Change Notice

PCN No: 128

Notice Type: Product Revision Change

Product Type: SL162

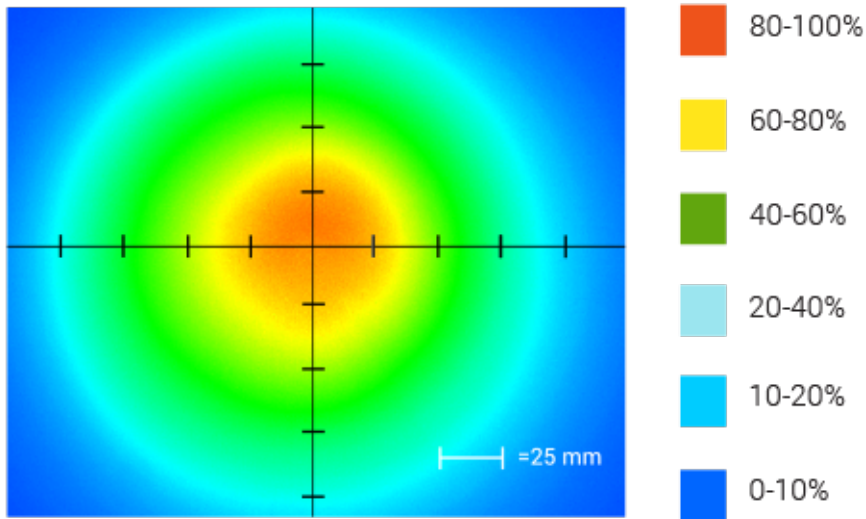
In an effort to improve our products, Advanced illumination (Ai) will update the LEDs used in the SL162 design. This change will result in a brighter, more uniform light at the same price*. Customers may still buy the current revision of this model until July 15th of 2016. After that time, orders for these products will be converted to their respective SL162 Revision A models.

This LED change will result in additional wavelengths being available: 365nm, 375nm, 385nm, 395nm, 405nm, 455nm, 470nm, 505nm, 530nm, 590nm, 625nm, 660nm, 730nm, 850nm and 940nm. Additionally the white LED color temperature will be changing from 6100K to 5500K.

Intensity Distribution

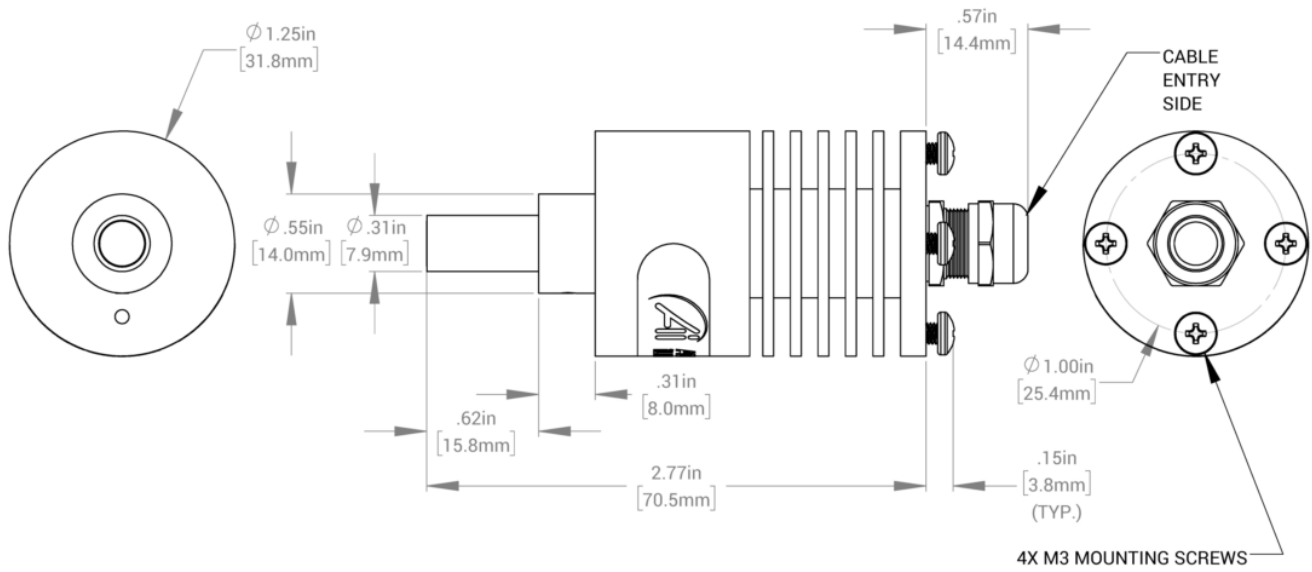
Optical measurement taken using SL162-WHIC Rev. A @300mm
